**Summary of Proposed Amendments to the Trent Source
Protection Plan and Assessment Report – King’s Bay
Drinking Water System**

*Pursuant to Section 34 of Ontario Regulation 287/07 of the Clean Water
Act*

The City of Kawartha Lakes is revising the Wellhead Protection Area (WHPA) for the King’s Bay Drinking Water System (DWS) due to the installation of a new well. These upgrades have resulted in the Proposed Amendments to the Trent Source Protection Plan (SPP) and Assessment Report (AR) (last updated and approved DATE) listed below and summarized and highlighted in yellow on the following pages. A strike-through indicates that text is to be removed.

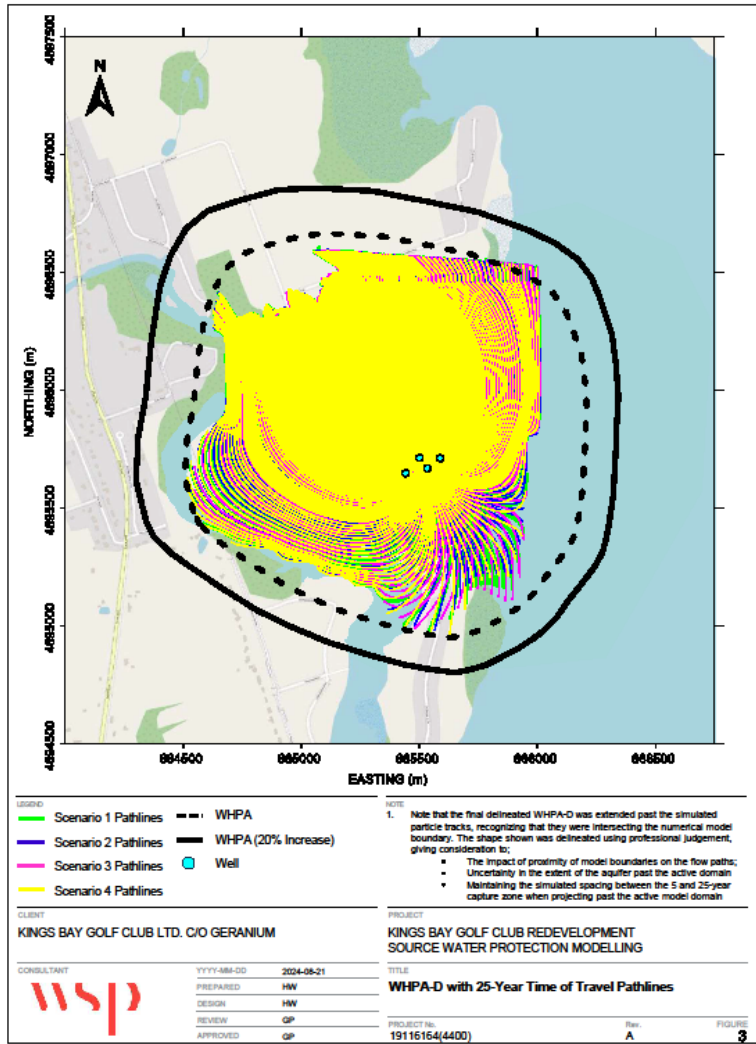
A figure illustrating the 25-year time-of-travel capture zone is shown below. The figure shows the time of travel particle tracks for all four scenarios along with the outline of the capture zone and the outline of the capture zone with the factor of safety applied.
